Product Change Note (QMS-FOR064_1)

iPCN000002 / 1 Nov 2022

Product Change Notice

CHDX8-227 / CHDX8-227C / CHDX8-327 / CHDX8-327C
CHDX8-228 / CHDX8-228C / CHDX8-328 / CHDX8-328C
CHDX8-230 / CHDX8-230C / CHDX8-330 / CHDX8-330C

Photo 1

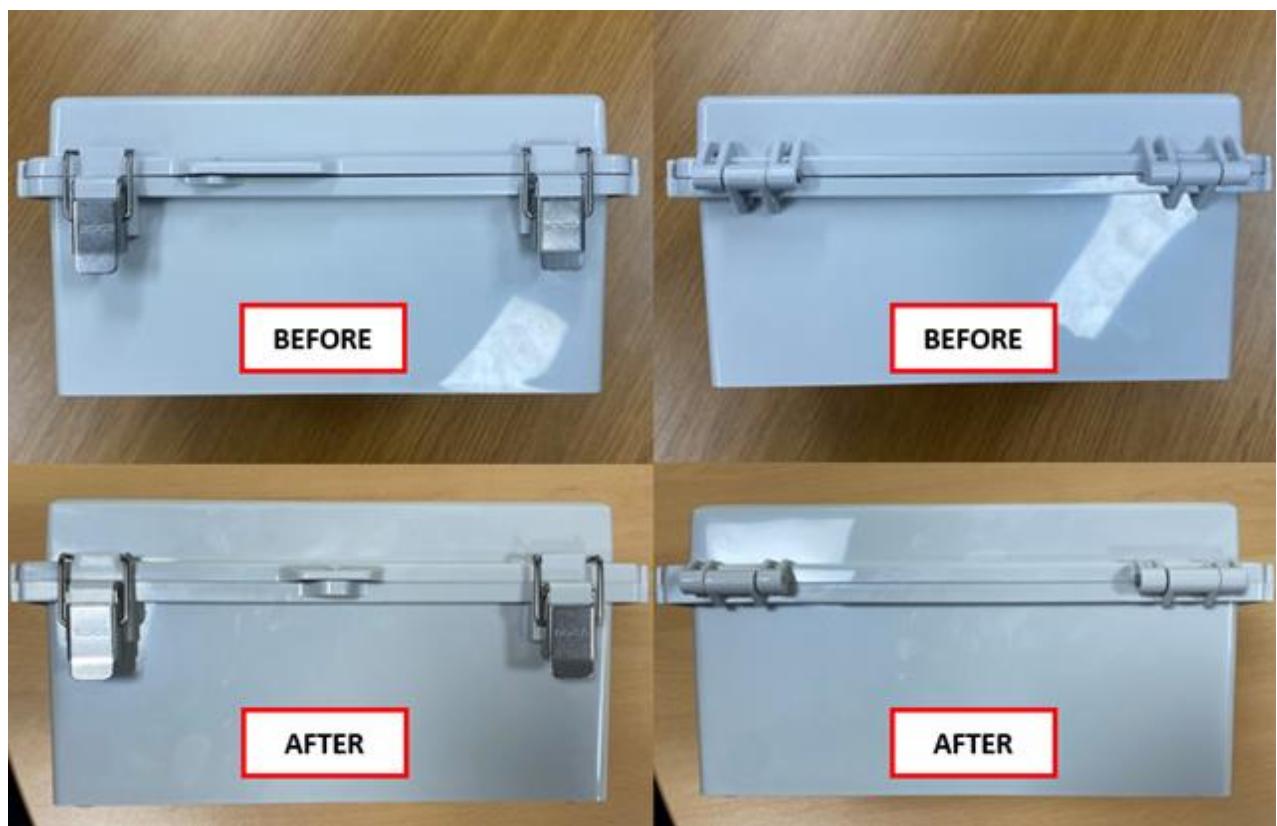
Minor cosmetic changes (modifications do not affect function of products):

- A. The external edges of the enclosure are now more angular/square
- B. The locking flange point has moved to a central location and the hole is smaller than before.
